Mobile Pentium® II Processor Specification Update

Release Date: November 1998

Order Number: 243887-004

Figure 1. An Example of Micro-controller Driven Thermal Management

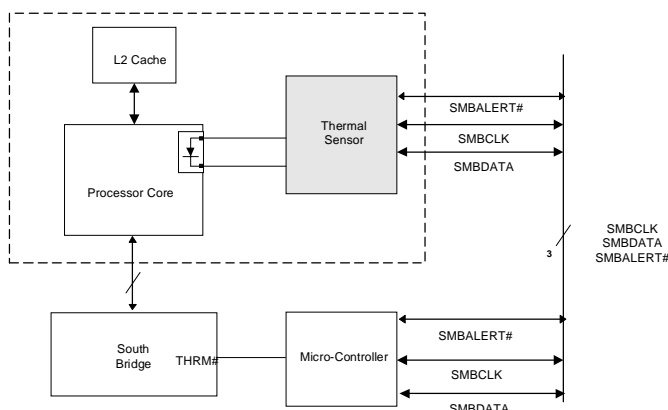
PROBLEM: The Mobile Pentium II processor and the Pentium II processor Mobile Module have a thermal sensor that monitors the processor core's temperature. Please note that desktop systems could have a similar thermal device. The thermal sensor asserts SMBALERT# if the processor temperature exceeds the temperature limits set in the Alarm Threshold Registers (T_{HIGH}, T_{LOW}). It also sets the corresponding Status Register bits to identify the cause of the interrupt. Figure 1 gives one example of the how the SMBALERT# signal could be used in a system.

Under the conditions described below, the thermal sensor incorrectly generates the SMBALERT# interrupt. *All* of the following conditions must be met to trigger a false interrupt:

Figure 2. Workaround Flowchart: SMBALERT#-Driven System

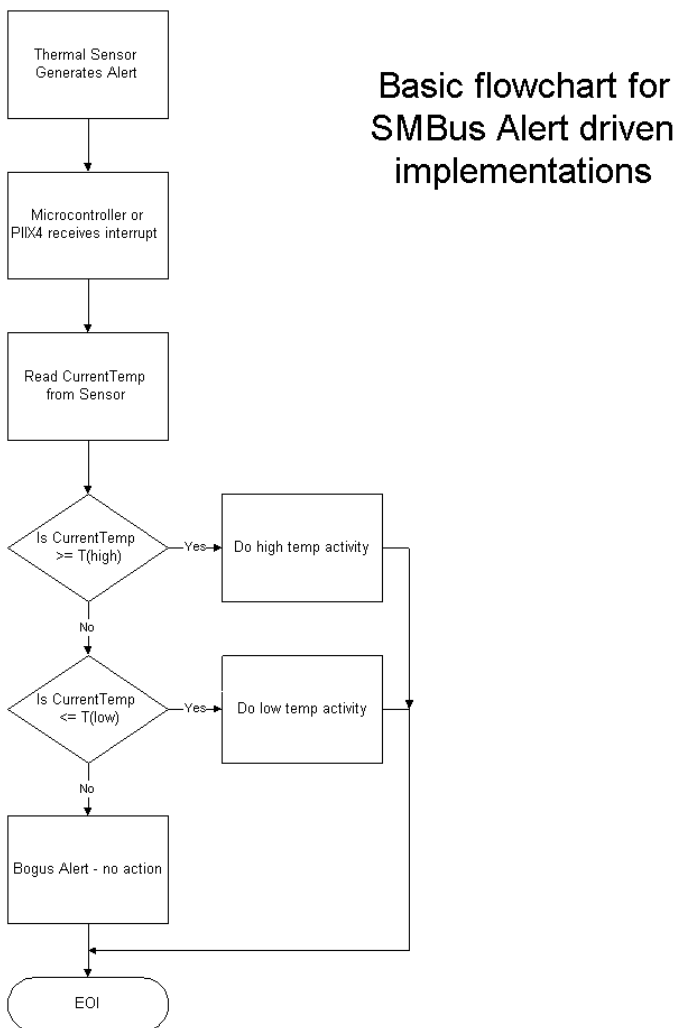
B30. Thermal Sensor May Assert SMBALERT# Incorrectly

WORKAROUND: Three different (mutually exclusive) workarounds are possible:

1. Before servicing an interrupt from the thermal sensor, read and compare the processor thermal reading with the threshold limits (T_{HIGH} or T_{LOW}). Figures 2 and 3 provide basic flowcharts for the implementation of this workaround in an interrupt driven system.
2. If the firmware implemented polls the Status Register only, then before taking any action, re-read the temperature register and do a comparison with the alarm threshold limits (T_{HIGH} or T_{LOW}) to determine if the value is actually still within the temperature window.
3. Use a temperature polling scheme to monitor the processor temperature.

Figure 5.6. Cross Sectional View With Vertical Dimensions

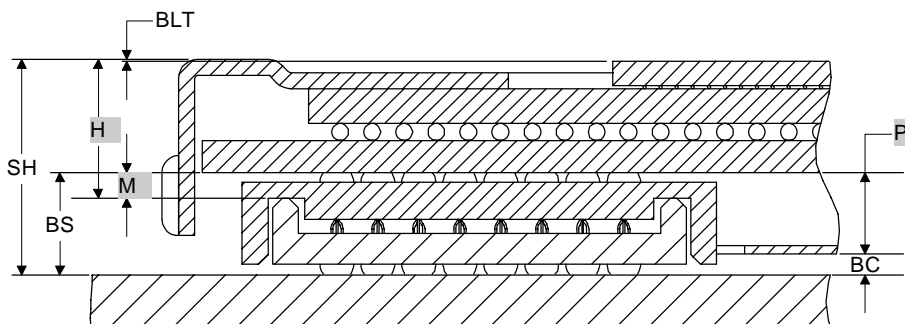
B12. Misabeled Vertical Dimension Parameters

Figure 5.6 in the *Mobile Pentium® II Processor at 233 MHz, 266 MHz, and 300 MHz* datasheet should be replaced by the following figure:
